Ducted Systems Technical Services Service Letter

Letter: **YS-002-2020**

Subject: **Nuisance low-pressure switch fault – Low ambient conditions - 3.5 ton (2nd generation) models**

Product: YHE42B22S, TH4B4222S, RHP14L42B22S, RHP14L42B23S,
THE42B32S, THE42B42S

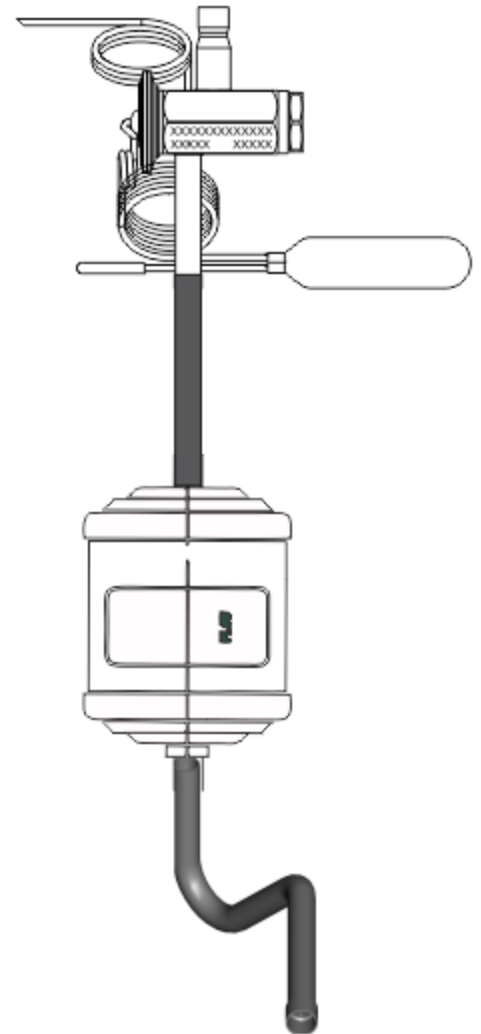
We have received complaints of nuisance low-pressure switch faults/compressor lockouts on the above-listed models. We have investigated this issue and were able to replicate the faults as described. When the above mentioned 3.5-ton models were converted from the Bristol reciprocating compressor (generation 1 model) to a Copeland scroll compressor (generation 2 model), the outdoor metering device was also changed from a TXV to a fixed orifice device as shown to the right.

Our investigation revealed that even with a properly charged system when this model is operating in conditions lower than 15 degrees Fahrenheit, nuisance low-pressure switch trips will occur. The 15 degree Fahrenheit temperature data was verified through extensive engineering cold soak testing. The 5438494 demand defrost control utilized in this model unit ignores the low-pressure switch input during the following conditions:

For installations where the above-listed model heat pumps are installed and operated in heating mode in conditions where the outdoor ambient temperature is lower than 15 degrees Fahrenheit, a repair must be made. There are two methods allowed for field repair.

If the heat pump is located in a climate that routinely experiences outdoor ambient conditions lower than 15 degrees Fahrenheit, the existing piston metering device needs to be replaced with a TXV. This repair is listed as the preferred method.

If the heat pump is located in a climate that rarely experiences outdoor ambient conditions lower than 15 degrees Fahrenheit, a temperature switch can be used to offer loss of charge protection. This repair is listed as the alternate method.

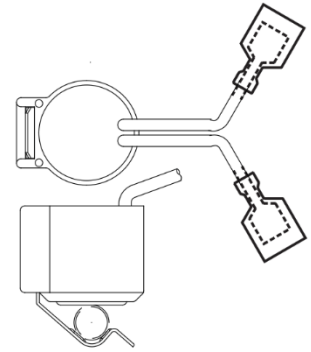
With the control panel swung open and the lower block off panel removed, there is adequate access to the existing metering device, filter drier, etc. Source One repair kit S1-32547301000 contains the following items:

Using a tubing cutter, the existing 3/8 distributor line can be cut directly above the piston metering device. The existing 3/8 copper tube connecting the liquid line base valve to the filter drier can then be un-sweat from the base valve. The entire assembly can then be removed from the unit. Using the components in the kit, the assembly shown to the right can be put together all at one time inside the unit and then perform the five 3/8 braze joints. The only other braze joint is the 1/8 TXV equalizing line into the suction tube connecting the reversing valve to the outdoor coil. The suction tube does not have to be replaced, therefore there is no need to worry about potential damage to the reversing valve. Specific step by step repair instructions have been included in the Source One kit.

- 1 - 5147597 - VALVE TXV
- 1 - 5256516 - DRIER - STEEL FILTER
- 1 - 1179260 - COPPER TUBE - LIQUID
- 1 - 5118412 - COPPER TUBE - LIQ TXV
- 1 - 158194 - CLAMP
- 1 - 158198 - SCREW CAP HEX 1/4
- 1 - 14976 - INSULATION - TXV BULB FOAM
- 2 - 7315 - CABLE TIES
- 1 - 13028 - PAD
- 1 - 348120 - SCREW
- 1 - 5917066 - INSTALL MANUAL - 14 SEER TXV RE-WORK KIT
